RE: **Recall Campaign Launch Notification**
Relocate Grounding for the Illuminated Star
MY20 167 (GLE-Class, GLS-Class)

Campaign No. 2020100015, November 2020

SUBJECT: **Model GLE-Class and GLS-Class vehicles (167 platform)**
Model Year 2020
Installation of the Illuminate Star

Figure 1

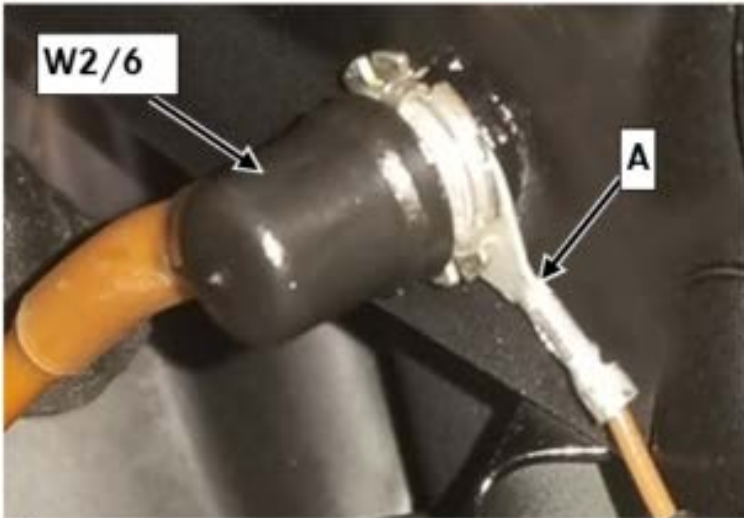
1. Open hood.
2. Switch off ignition and store transmitter key outside the transmitter range (at least 2 meters).
3. Unscrew ground **point W2/6**.
i For basic data, see **GF00.19-P-2001-17NCA**.
4. Remove illuminated star ground line (**A, figure 1**).

6. Route illuminated star ground line (**A, figure 1**) to jump-start connection point and attach to threaded pin of jump-start connection point.
7. Screw on brass sleeve (**B, figure 2**).
Nm Brass sleeve **16 Nm**.
8. Secure illuminated star ground line (**A, figure 1**) up to jump-start connection point.
i Ensure a chafe-free routing and attachment of the illuminated star ground line See **AZ88.40-P-0011-01ME**
9. Check anti-twist protection (**C, figure 3**) of cable lug of ground **point W2/6** for damage.

Figure 3 (OK)

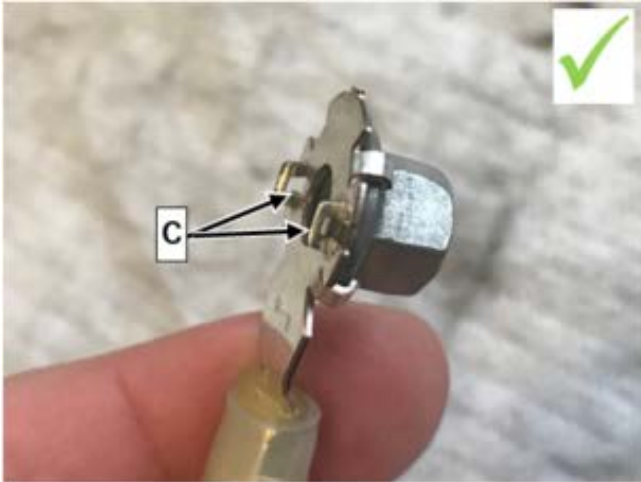
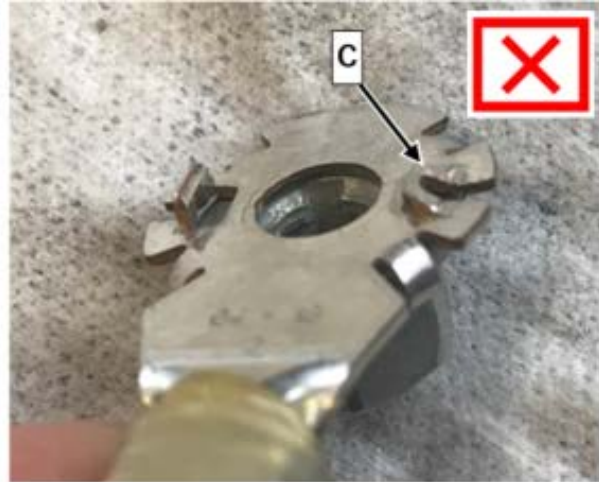
- a. Anti-twist protection (**C, figure 3**) **straight** or **bent outwards**, i.e. outside dimension between anti-twist protection lugs (**D, figure 4**) **equal to or greater than 13.6 mm**: Perform operation step 11, then **end measure**.
- b. Anti-twist protection (**C, figure 3**) **bent inwards**, i.e. outside dimension between anti-twist protection lugs (**D, figure 4**) **less than 13.6 mm**: Create **PTSS case**.

Make detailed photos of anti-twist protection of ground line, ground point W2/6 in removed condition. Clarify the further repair procedure via a **PTSS case**. Keep faulty part.

Figure 4

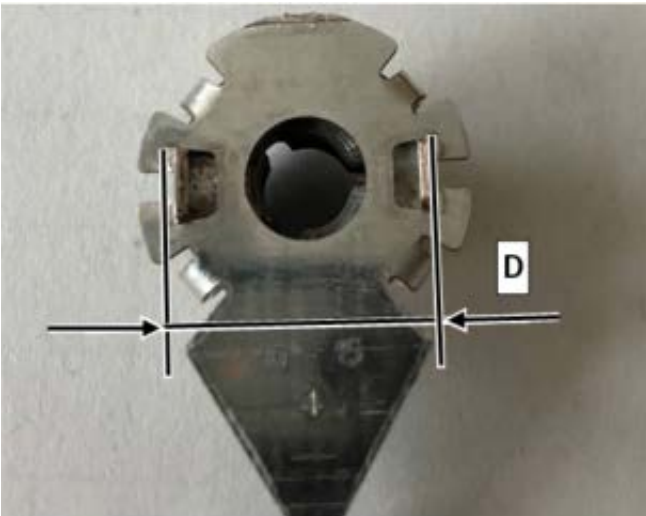
10. Measure outside dimension between anti-twist protection lugs (**D, figure 4**).
i Outside dimension between anti-twist protection lugs (**D, figure 4**) **min. 13.6 mm**.

i Only if anti-twist protection of cable lug is **bent inwards** , i.e. outside dimension between anti-twist protection lugs (**D, figure 4**) is **less than 13.6 mm**.
